**5.1 NO. 14 (LOT: 119; D/P: 1223) FRANKLIN STREET, LEEDERVILLE - PROPOSED THREE GROUPED DWELLINGS**

That Council, in accordance with the provisions of the City of Vincent Local Planning Scheme No. 2 and the Metropolitan Region Scheme, APPROVES the application for Three Grouped Dwellings at No. 14 (Lot: 119; D/P: 1223) Franklin Street, Leederville, in accordance with the plans shown in Attachment 2, subject to the following conditions, with the associated determination advice notes in Attachment 9:

The applicant elected to make the following changes to the proposal subsequent to the Council Briefing Session on 20 July 2021. These changes are reflected in the amended development plans contained in **Attachment 2**.

Original unit 1 west elevation

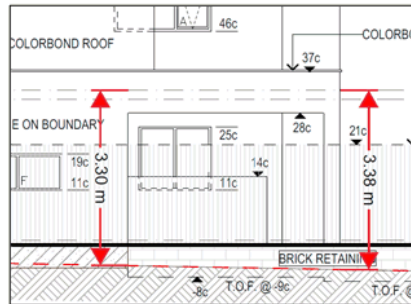
**Response** The plans have been amended to reduce the upper floor wall heights no less than 6m through change in roof form. The ground floor alfresco and scullery wall height does not exceed 3.5m (and all habitable spaces will be screened by the dividing fence) and therefore does not require more than a 1.5m setback. The reduced setback requirements are as follows:

With the reduced wall heights proposed, the setbacks are generally consistent with that existing and typically expected within the R30 coded residential area. The impact of bulk is moderated through a number of features including the varied setbacks across the wall length, contrasting finish with the ground floor, numerous and larger windows to reduce the visual presence of the wall into smaller elements, and replacement balcony side wall has also been modified to include screening rather than solid wall which further reduces bulk whilst also improving amenity to the future residents with improved light and ventilation.

Wall height for lot boundary setbacks

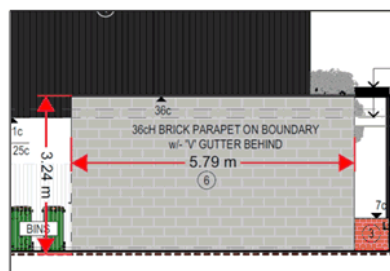
The variation relating to the ground floor alfresco area is considered incorrect, as the natural ground level to ceiling height is no greater than 3.5m at any point along the boundary, nor is the finished floor level more than 0.5m above the natural ground level at any point, accordingly the setback requirement is 1.5m; a 0.5m variation.

The extent of impact for the reduced setback is minimal, the wall is adjacent to an open area with virtually unencumbered access to light and ventilation, the visual impact of the wall will be minimal, further reduced by portion of the wall relating to an alfresco area which is open in nature and will also be largely screened by a 1.8m high dividing fence. As the finished floor levels closely align with the finished ground levels there will also not be any privacy impacts once the dividing fence is erected.

Boundary wall (original)

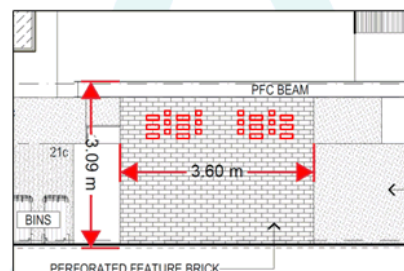
**RFI** Proposed unit 1 garage boundary wall with an average height of 3.3m in lieu of 3.0m permitted to the western lot boundary.  
The City will undertake community consultation in relation to these variations prior to forming a position.

**Response** The boundary wall has been amended, reduced in height and length as part of the changes to replace the proposed garages with carports. The wall length and height have been reduced to 3.6m and 3.1m respectively. There is limited scope for impact, as there appears to be only one window which will be adjacent to the wall on the affected property, and this room also includes significant windows within the façade, which will mitigate potential loss of light and ventilation as a result of the boundary wall. The adjacent space is otherwise inactive and does not provide any function for the dwelling.

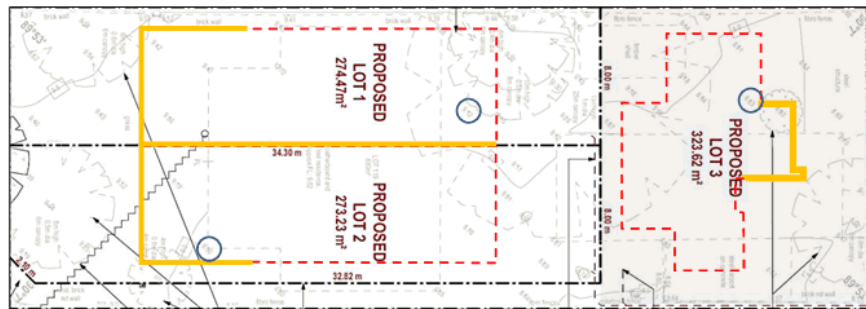
- RFI**
- Proposed unit 1 with a skillion roof height of 6.5m to the low side and 7.3m to the high side in lieu of 6m and 7m permitted respectively.

Please review the proposal and advise whether there is any opportunity to reduce the finished floor level of this unit to reduce the extent of the building height variation.

**Response** The amended roof form has resulted in considerably lower building wall heights, the table below stipulates the natural ground level where a 6m building height would result based off of the wall heights proposed which can be cross referenced against the diagram below to determine building height.
